Seismic Walkdown Checklist (SWC)

Diablo Canyon Power Plant, Unit 2

**DIABLO CANYON NUCLEAR
POWER PLANT UNIT NO. 2
AUXILIARY FEED WATER
PUMP SUCTION**

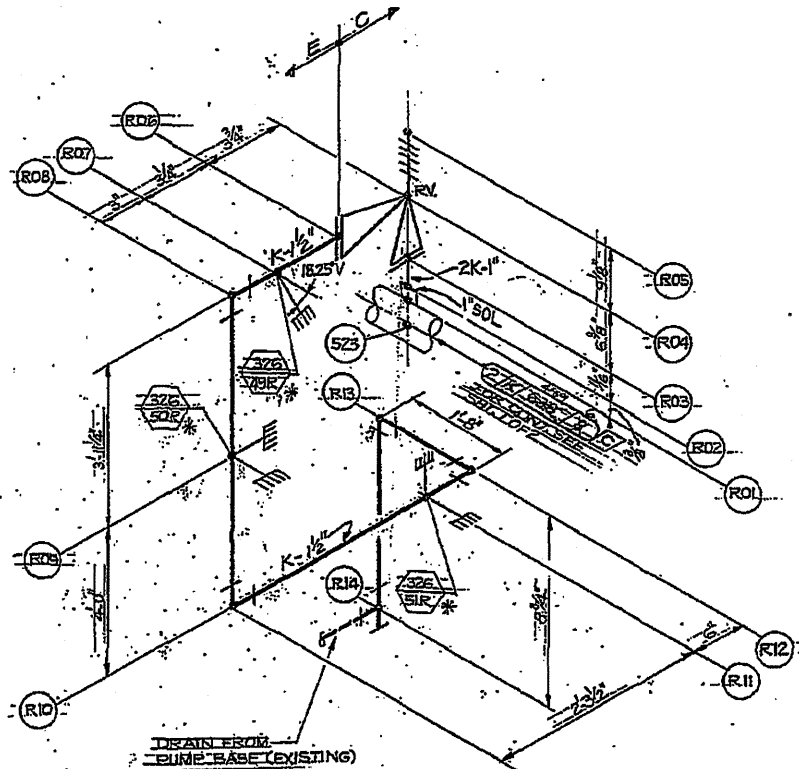
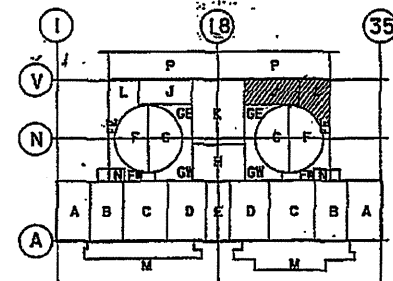
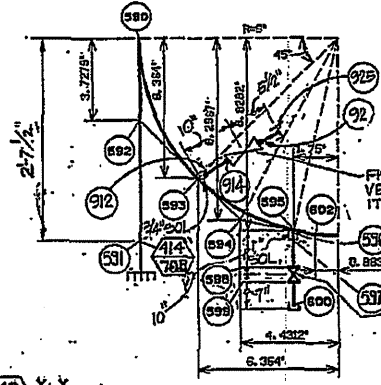
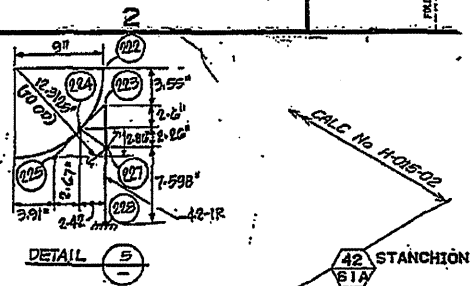
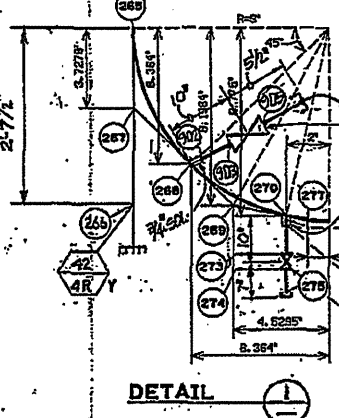
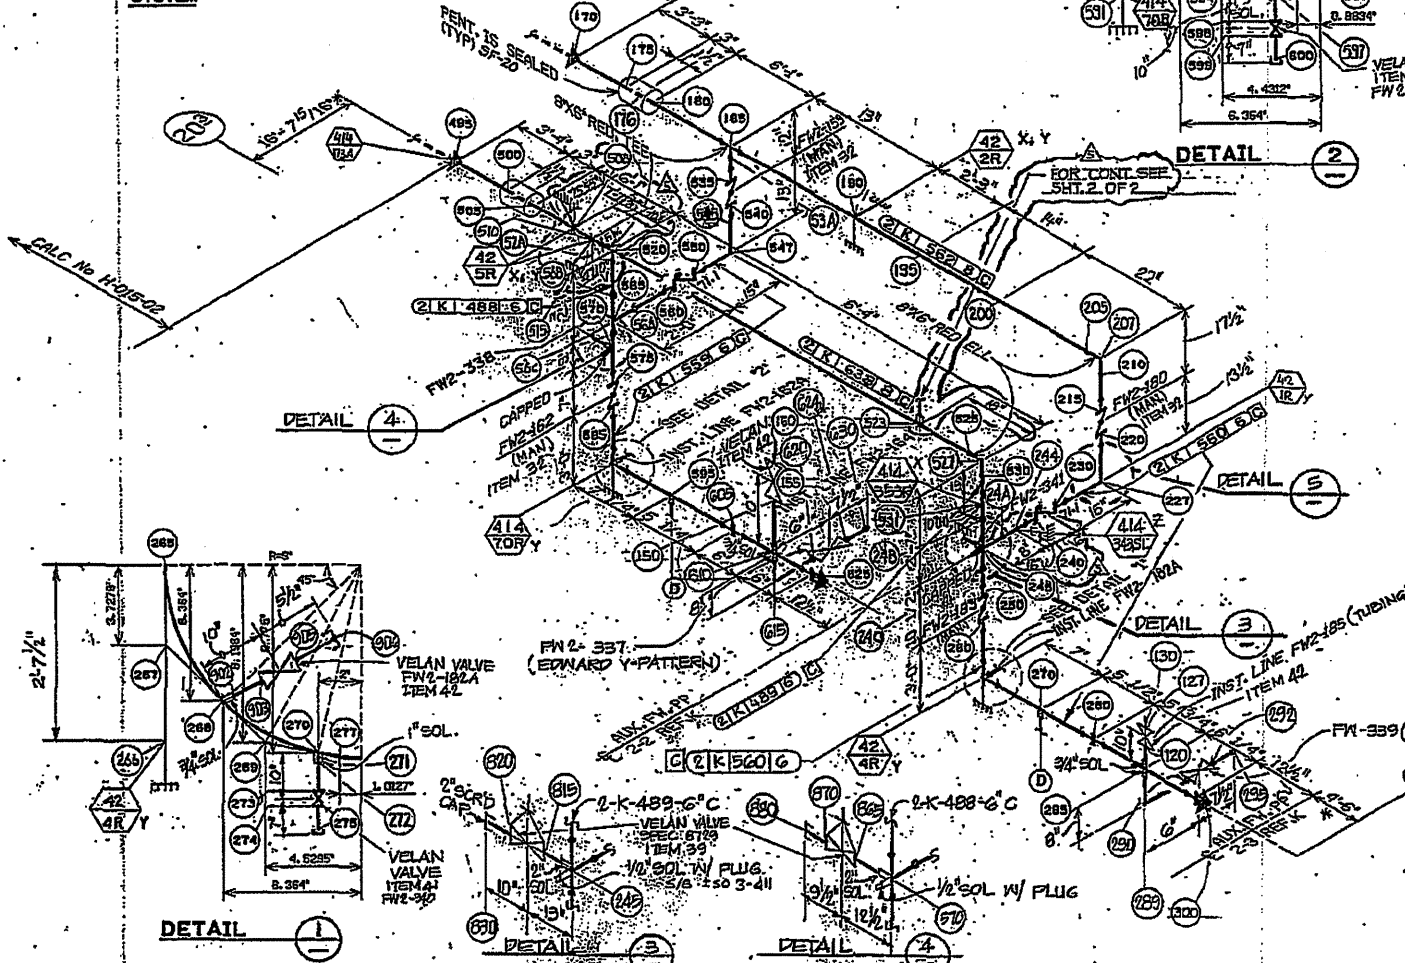
From a field walkdown, there is a minimum gap of $\frac{1}{4}$ " (0.25 inches). The RV in question is mounted to the top of Aux Feed Water Pump Suction line K-238-8. The attached piping analysis run (pages 2-4) shows that the RV is attached at Node 523, and the deflections at this node in the x-direction (i.e. the direction of the nearby firewater piping) are equal to 0.01" when both the thermal and seismic displacements are added together (load cases THRM(N1) and SEISHX). Additionally, the firewater line has rigid supports both upstream and downstream of the RV, so it's lateral displacements will be minimal.

Sheet 37/81

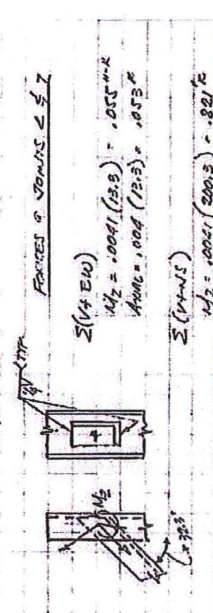
Motor Operated Damper DC-2-23-P-D-VAC-2-MOD-12 was modified at some time in the past by adding structural steel channel stiffeners on the top and bottom of the damper. The channel sections also extend to and stiffen the damper immediately adjacent to MOD-12 (DC-2-23-P-D-VAC-2-MOD-12A). Reference PG&E Drawing 59353 for a layout of the dampers. The concern is that the heavy channel stiffeners may adversely impact the seismic qualification of the ducting/duct supports associated with the MOD Dampers.

A review of the seismic calculation for the ducting/duct supports associated with the MOD Dampers (Calculation HV-86, Revision 0) shows that the additional mass from the channel sections was not considered in the qualification of the ducting/duct supports. A copy of this calculation has been revised (marked up) such that it now accounts for this extra mass. This markup is found under sheets 2 thru 18. The mark up demonstrates that the ducting/duct supports would remain seismically qualified (with significant margin) if the additional mass from the channel stiffeners is considered.

- Revise Calculation HV-86 to account for the additional mass from the channel stiffeners.
- Issue the appropriate Design Change Vehicle to update the affected drawing(s)
